Re: Environmental Report for Indian Point 2
Docket No. 50-247

The Consolidated Edison Company of New York, Inc. (Con Edison) would like to furnish you with the following comments in response to the letters from Federal agencies enclosed with your letter to me dated October 27, 1970.

FIGURE 2

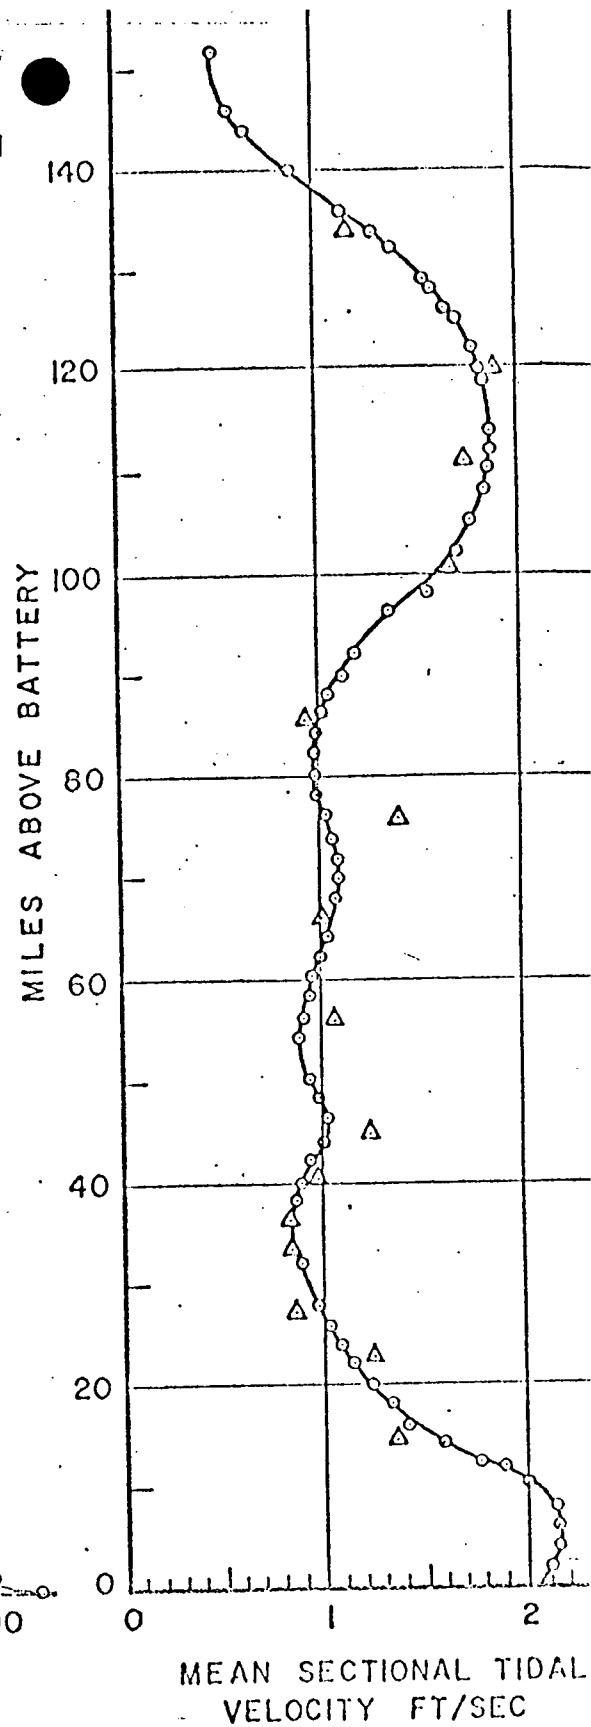
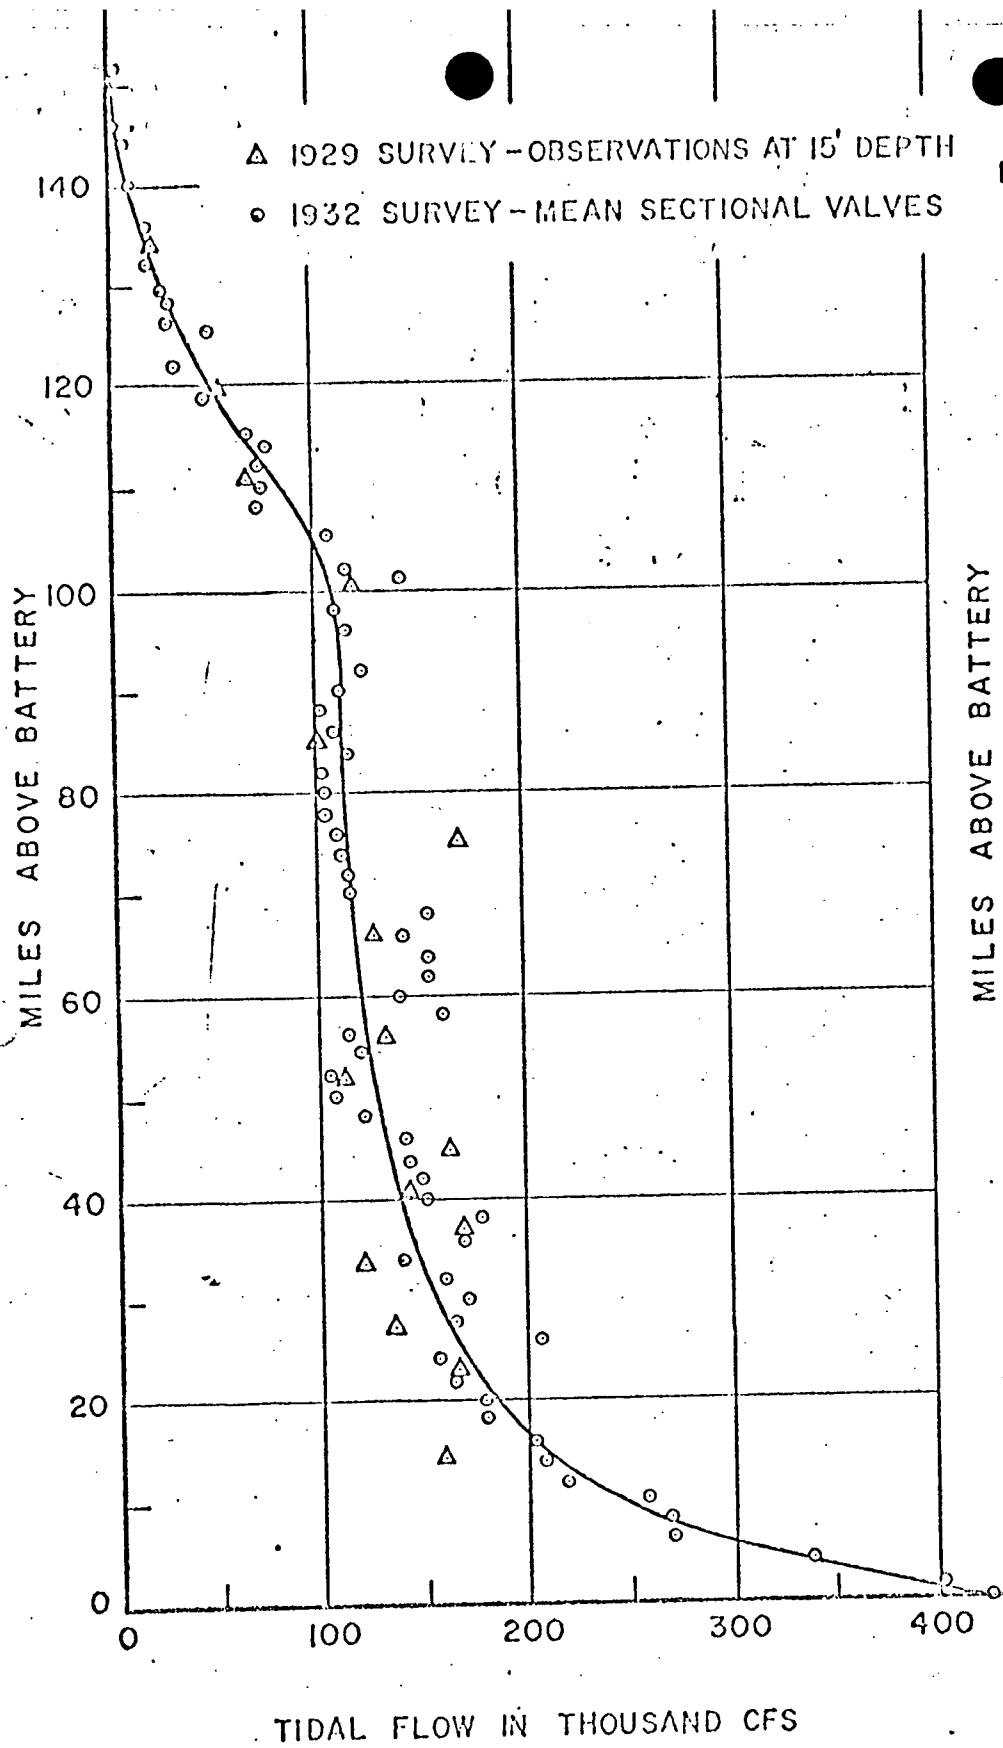
The Department of the Interior requested information on river flows. Flow in the Hudson River at Indian Point is affected more by the tides than the run off of the tributary water shed. The tidal flow at Indian Point is approximately 150,000 cfs (68 million gpm: the fresh

water runoff varies from 4000 cfs in August to 38,000 cfs in April. The attached figure 1 shows the variation of the tidal flow with location above the Battery and figure 2 presents the seasonal variation of the fresh water run off. The peak tidal flow past the plant will vary from 70 million gpm in August to about 80 million gpm in April. This does not suggest that all this volume rate of flow is available for dilution possibilities. The dilution capability is measured in terms of fresh water flow and the tidal and salinity parameters. However, the significant factor in terms of dilution in this region of the river is associated with the tides and the resulting saline intrusion.
